MIL-M-28787/143B(SH)
AMENDMENT 1
19 June 1991

MODULES, STANDARD ELECTRONIC

FLIP-FLOP, $J\overline{K}$, DIGITAL, KEY CODE GBB

This amendment forms a part of Military Specification MIL-M-28787/143B(EC), dated 19 January 1983, and is approved for use by the Naval Sea Systems Command, Department of the Navy, and is available for use by all Departments and Agencies of the Department of Defense.

FIGURE 28. Power supply transient amplitude test circuit for table XVIII.

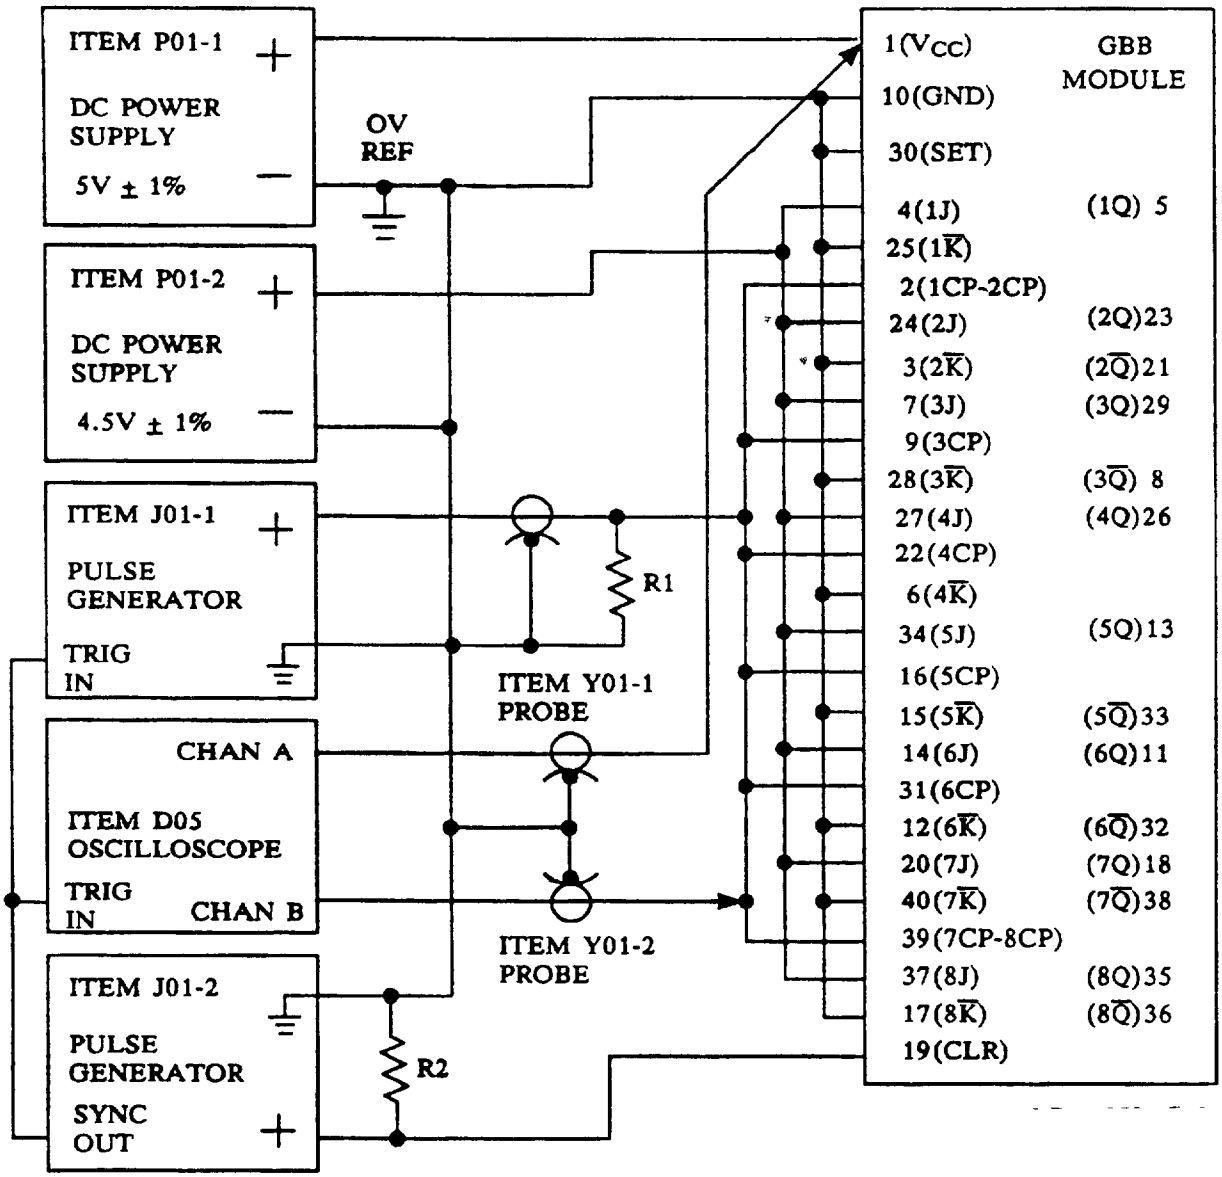
FIGURE 28, GBB module block Delete and substitute new figure 28 as printed on page 3 of this amendment

NOTE: R1 = R2 = 51.1Ω ± 1%, 1/4W
